BUREAU OF LAND MANAGEMENT FILLMORE FIELD OFFICE

In Reply Refer to:
3800
(U-010)
UTU-079464-01

Addendum to NOI/Plan of Operations

Dutson Stone Quarry

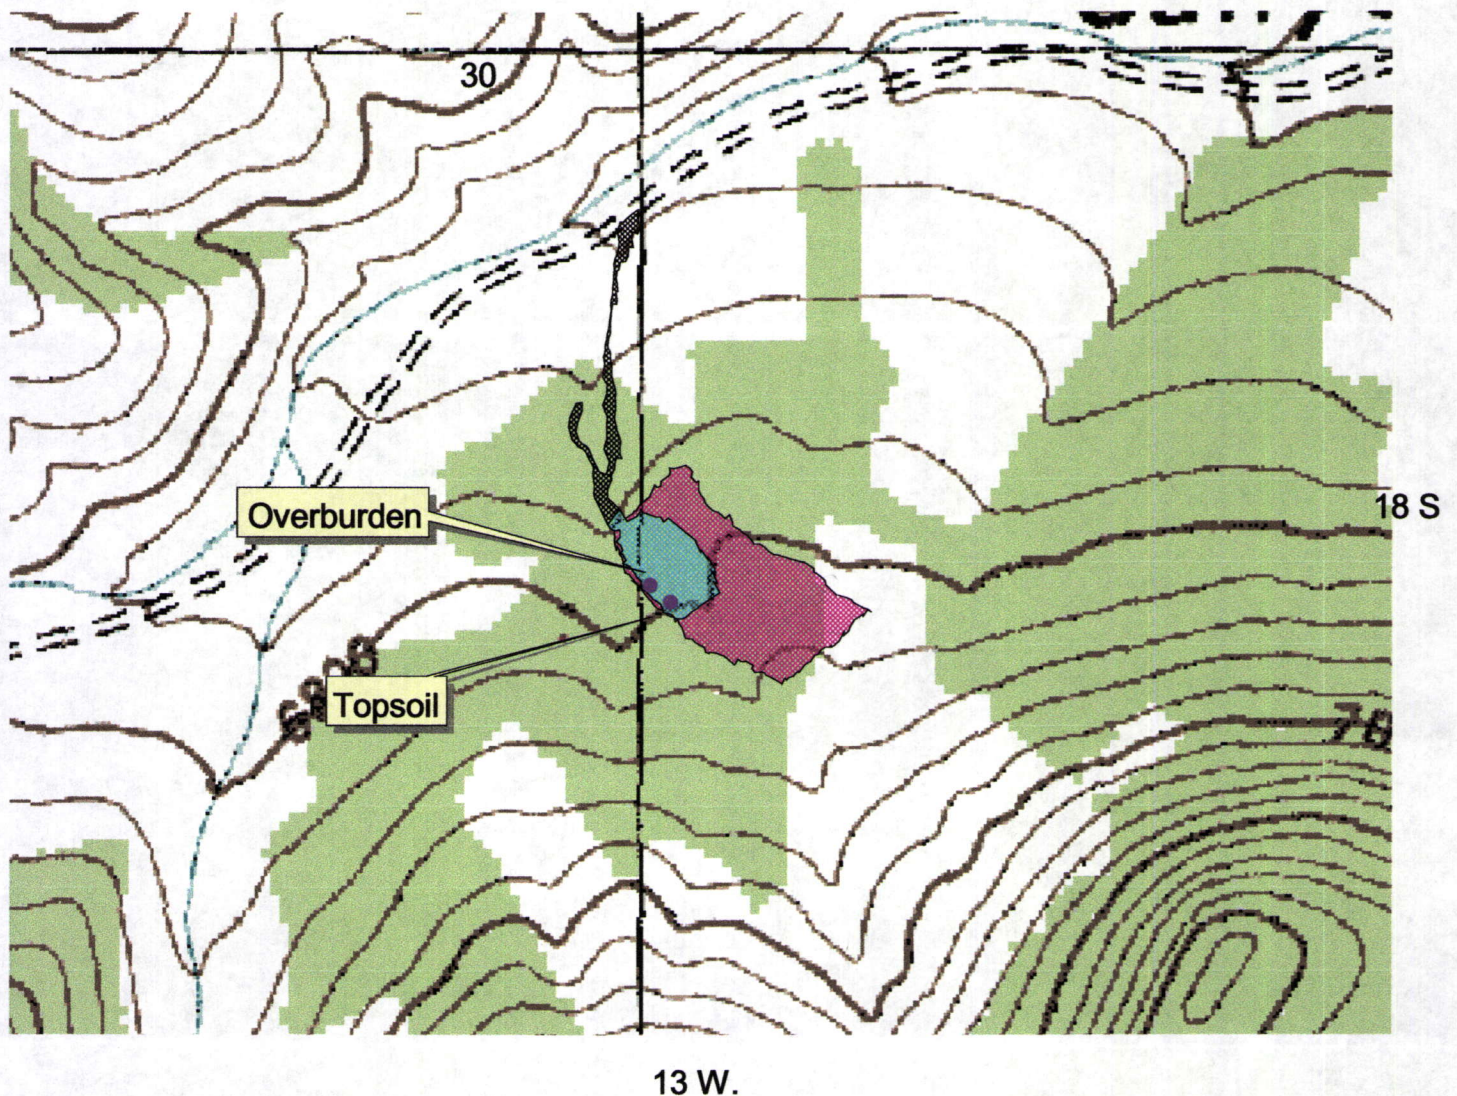
1. Overburden. Your mining plan indicates that a large amount of overburden will have to be removed from the rock outcrop. The site you have designated as the storage area is beside a drainage, and it appears to us that the stockpile will ultimately block the drainage.
2. Common Variety. As indicated to you in our March 28, 2002 letter, you will probably be required to establish an escrow for the value of the material removed until a mineral report can be completed. However, before making a final decision on the issue, we would like to afford you the opportunity to submit your rationale for believing the stone you are proposing to mine is an uncommon variety, and as such is locatable under the mining laws.
